20 June 2016

Tender Reference No. (267) in P/AE/PUR/AGC

**Renovation Works of New Headquarters
for Construction Industry Council**

Tender Addendum No. 1

1 38/F - HVAC PLAN
1:150

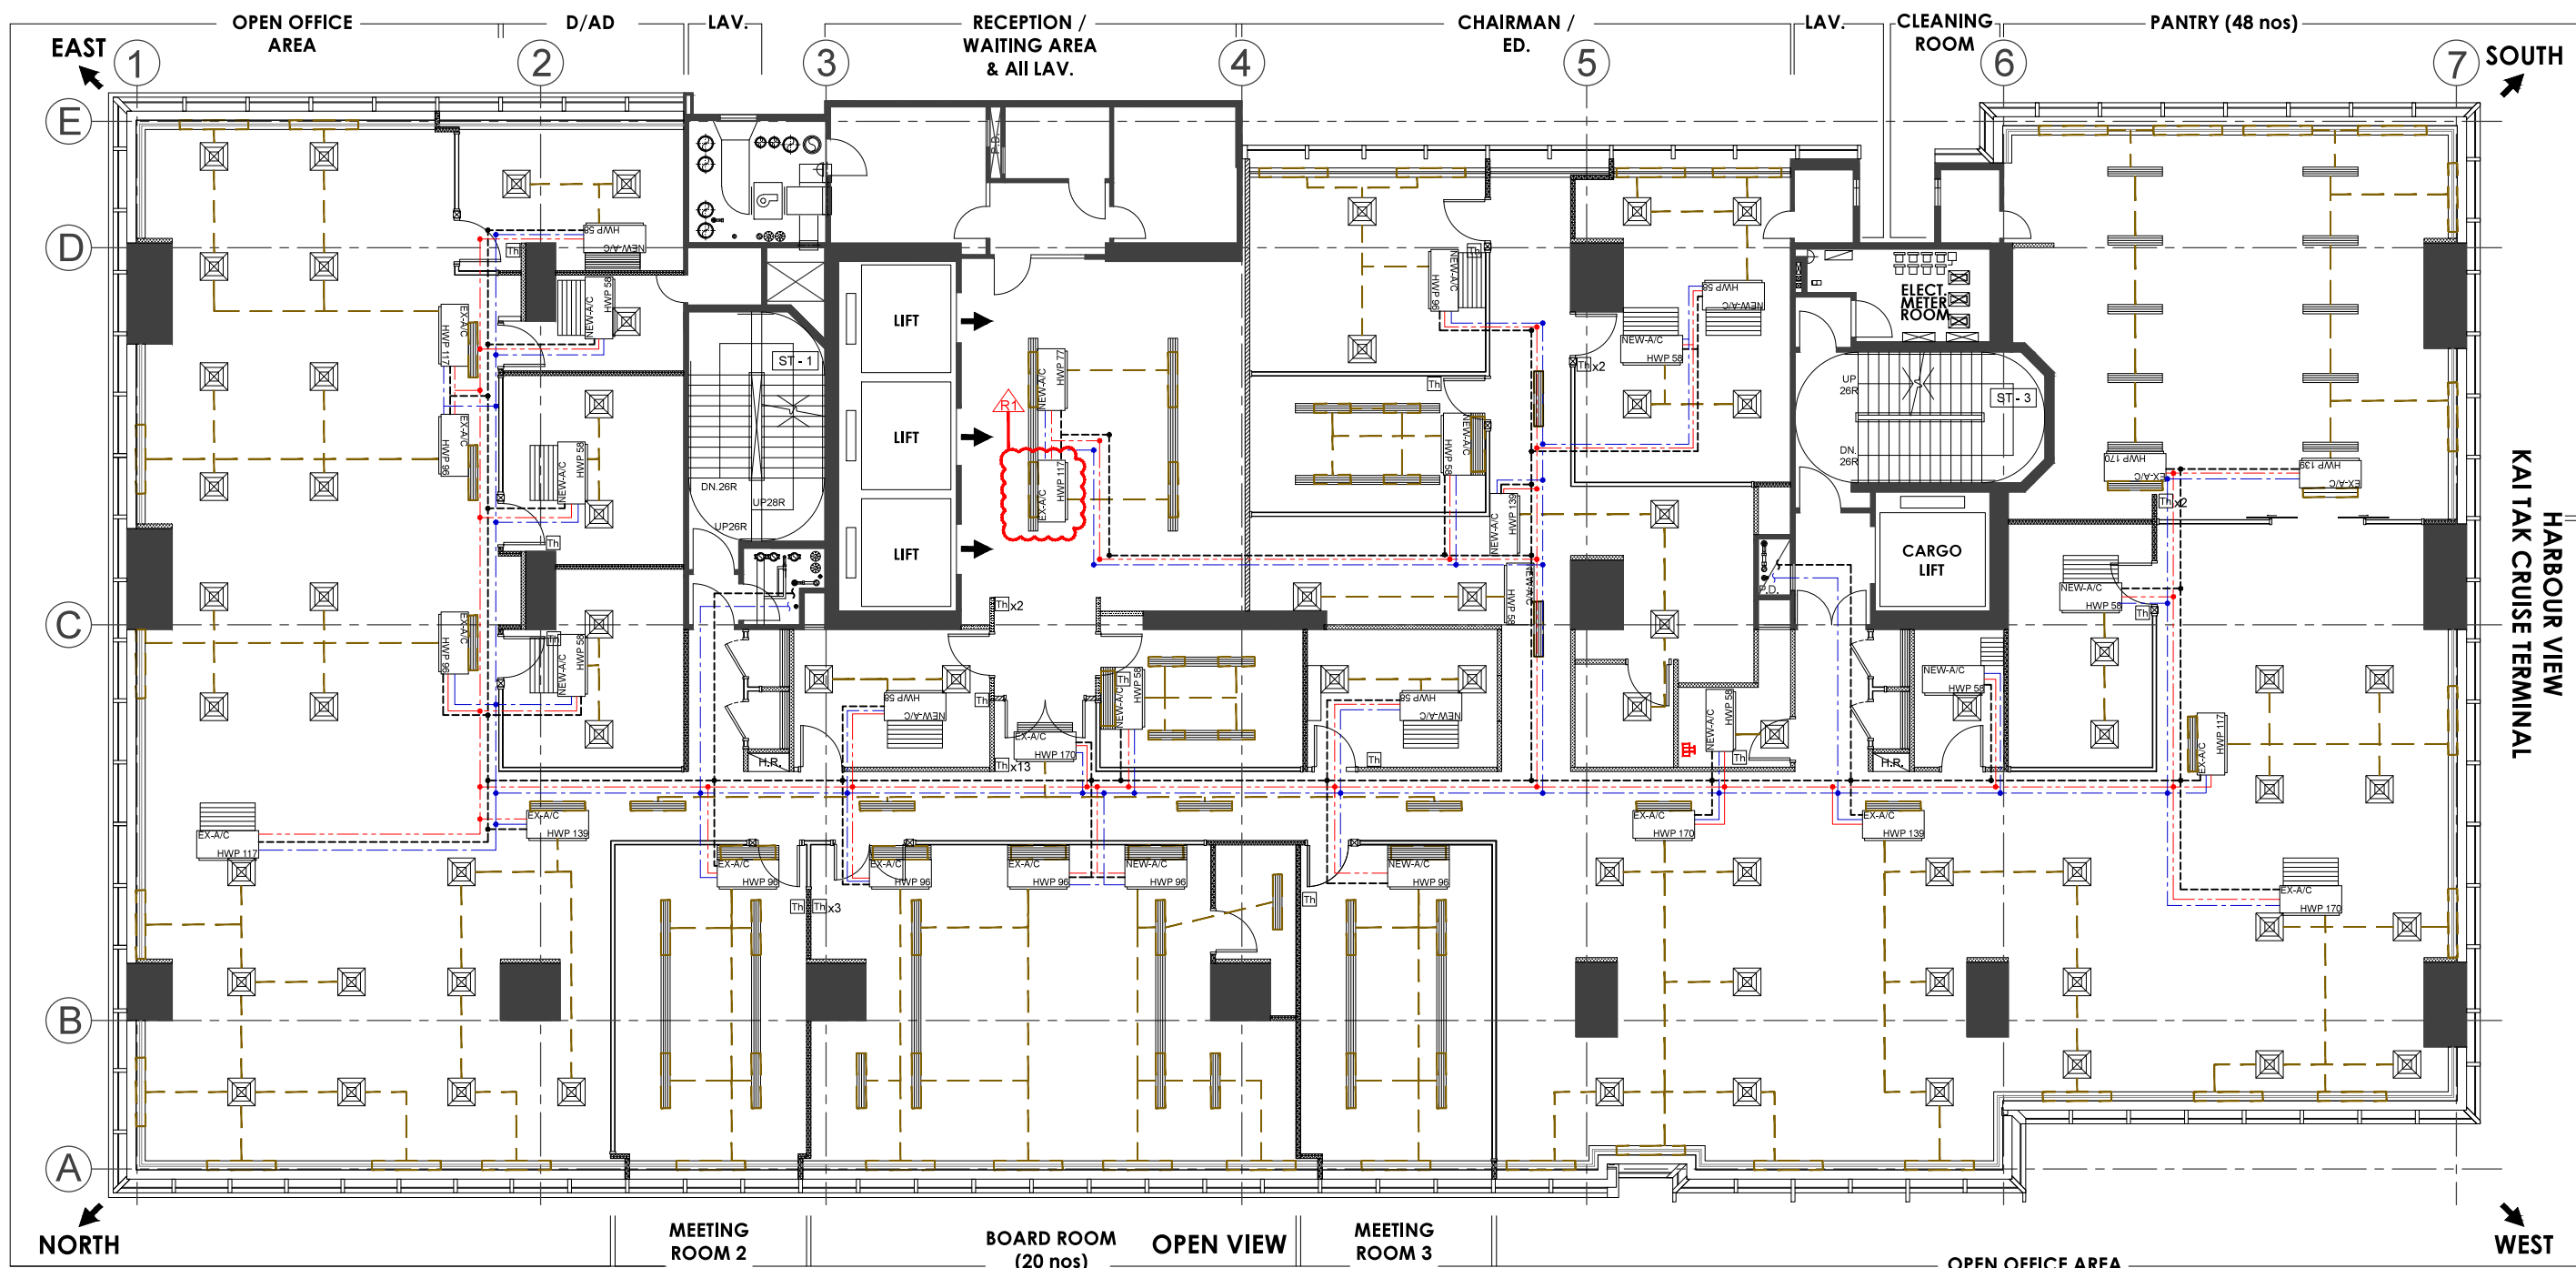
1. Annex 2 of Assignment Brief – Tender Drawings – Drawing No. DL-01 is replaced by Drawing No. DL-01-R1.
2. Annex 2 of Assignment Brief – Tender Drawings – Drawing No. 38-AC-01 is replaced by Drawing No. 38-AC-01-R1.
